# Access Compliance Report

## Public Rights-of-Way

| Intersection ID: 51776 | Main Street: MCVAY_ST   | Cross Street: ORANGE_ST | Location: W            |
| ADA ID: 84AE0ABD2D22   | Ramp Type: Directional1 | Initial Pass/Fail: Fail | Overall Compliance: No |

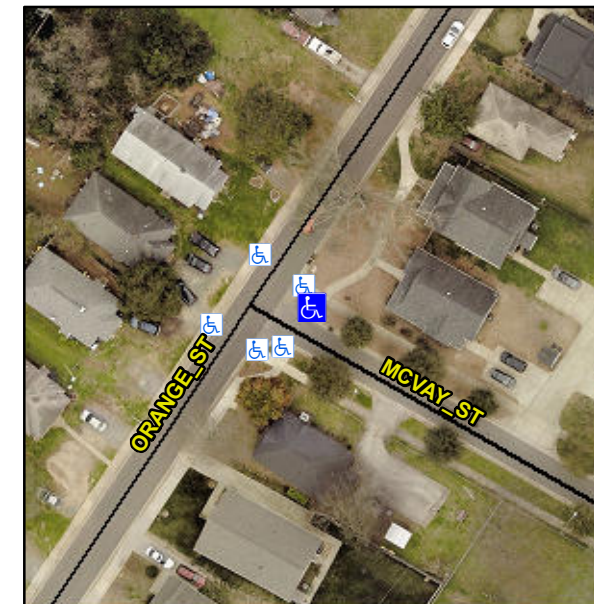
**R304.5.3**

| Compliance | Description           | Data  | Compliance | Description                 | Data |
|------------|-----------------------|-------|------------|-----------------------------|------|
| No         | Ramp XSlope (%)       | 2.3   |            |                             |      |

**Remove & Replace Entire Ramp.**
